CITY PLAN COMMISSION STAFF REPORT

Project Name
Emmanuel Science and Technology Center

Request
CD-CPC-2025-00037
Area Plan Amendment
CD-CPC-2025-00008
Rezoning without Plan
CD-CPC-2025-00004
Development Plan – Nonresidential

Development Plan Application Resubmittal 001
 Kansas City, MO: City Plan Commission
 02.14.2025

A1 Site Plan
 A1.02 1" = 30'-0"

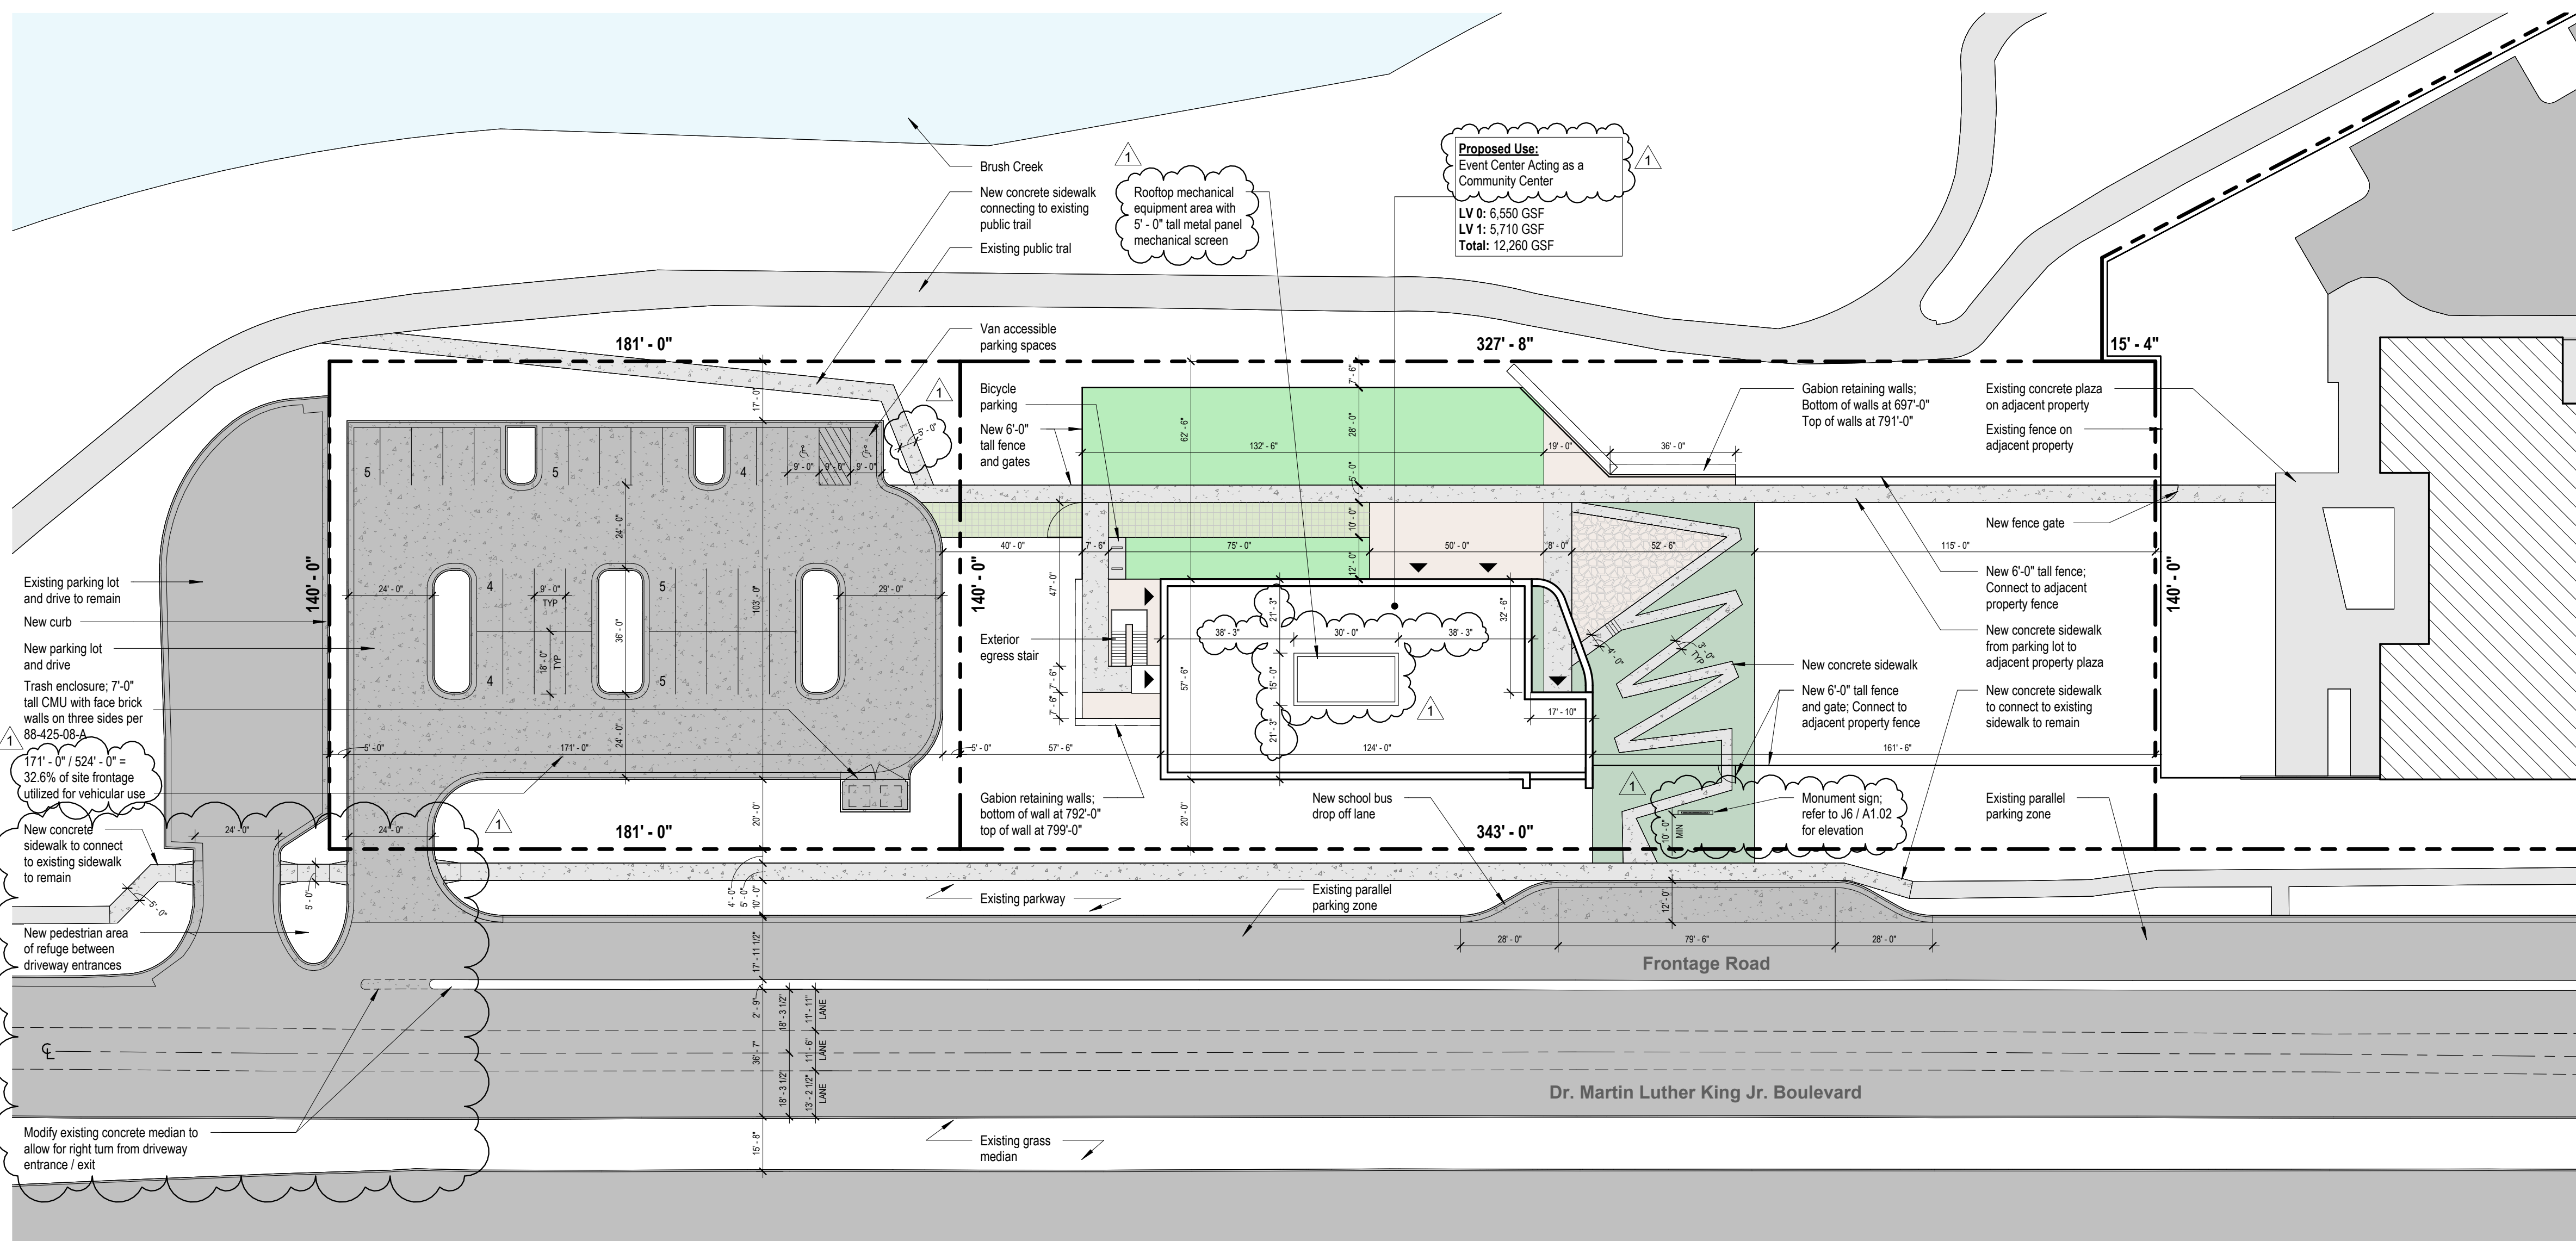
Variance 1 – A variance to 88-323-02-B (1) – If adjacent to and within 150 feet of a boulevard or within a development node, a vehicular use area must be located on the side or rear of the building. Parking located on the side of the building shall be set back a minimum of 10 feet behind the front building line or 30 feet from the right-of-way, whichever is greater.

Variance 2 – A variance to 88-323-02-B (3) – No more than 30% of a site's frontage adjacent to the boulevard or parkway may be used for vehicular use areas.

The applicant is proposing one new access point to their proposed parking lot from the frontage road on the western end of the subject site. The proposed plan shows the new access adjacent to the existing driveway to the Parks Department owned parking lot; the two driveways are also located at the intersection of the frontage road with Dr Martin Luther King Jr Boulevard. The proposed plan shows the existing median separating the frontage road from the boulevard being shortened in conjunction with a widened pedestrian refuge area between the two driveways. Public Works and Parks have both reviewed these changes to the frontage road and driveway access.

24. The developer shall continue working with city staff regarding the driveway entrances to both parking lots located at the western portion of the development.

Include on the site plan a pedestrian connection from the parking lot to the sidewalk along MLK Blvd.

J1 Building-Mounted Wall Sign
 1/2" = 1'-0"
 0 6" 1" 2"

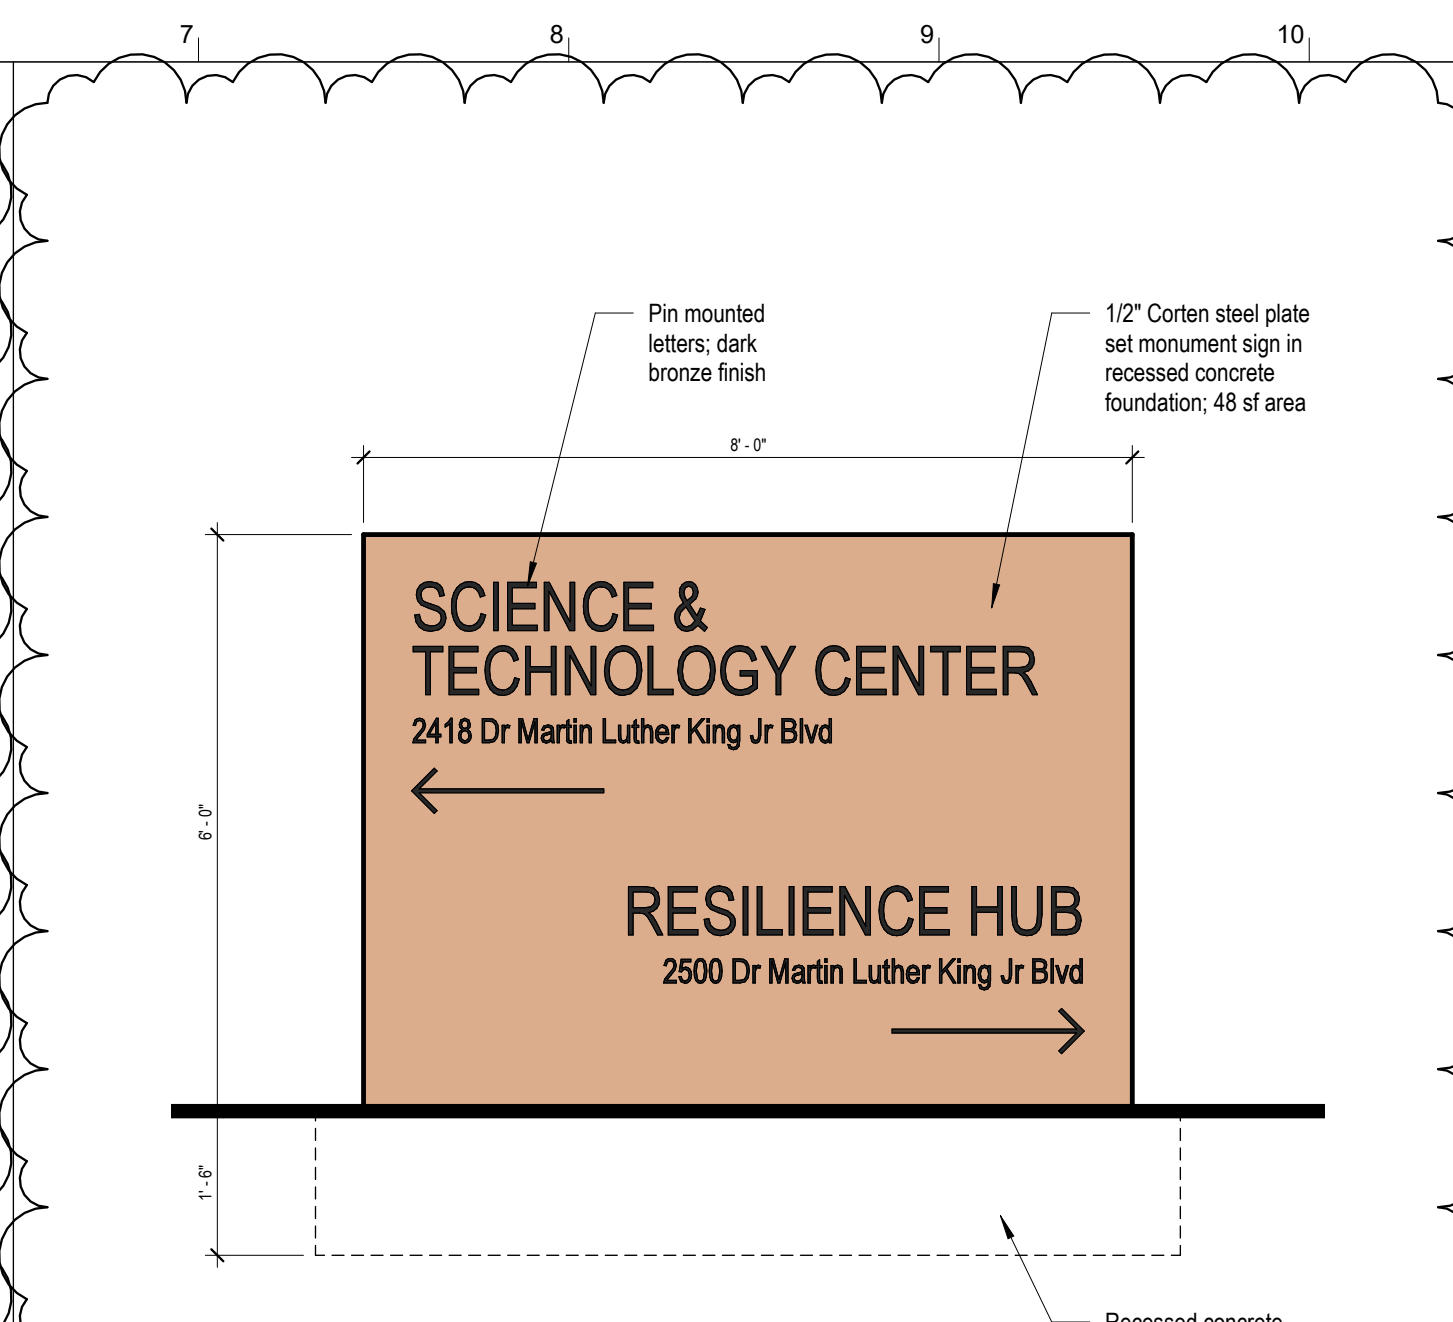
Variance 5 – A variance to 88-445-07 – A wall sign shall not exceed 50 square feet.

6. All signage shall conform to 88-445 and shall require a sign permit prior to installation.
7. That prior to recording the Final Plat the developer shall upload and secure approval of a Street Tree Planting Plan from the City Forester.

Building Elevations

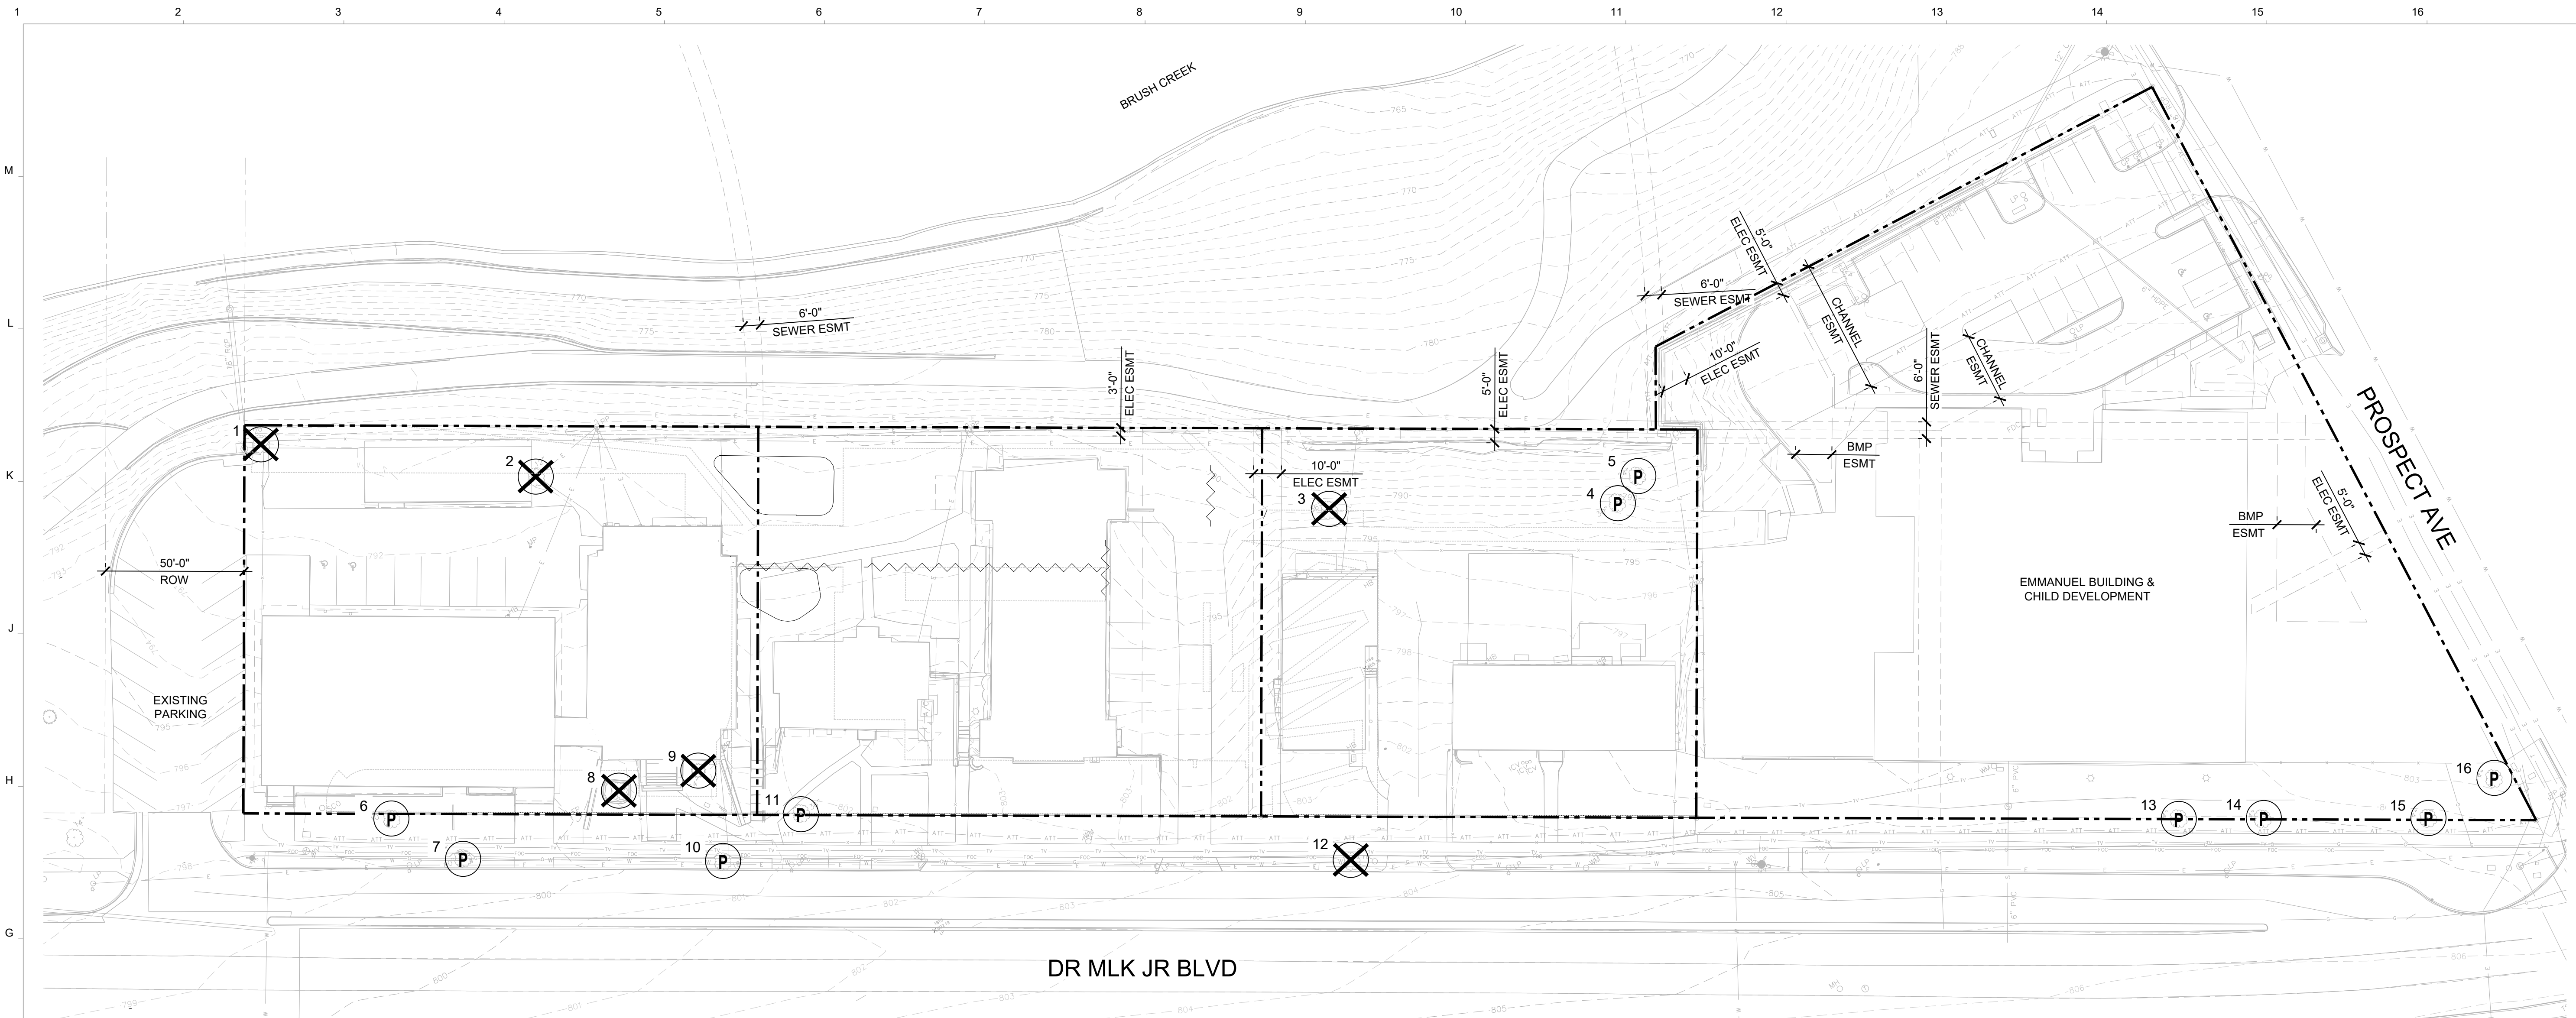
Variance 3 – A variance to 88-323-02-E (6) – If adjacent to and within 150 feet of a parkway, structures shall provide a minimum of 33% transparency on the ground level façade facing the parkway.
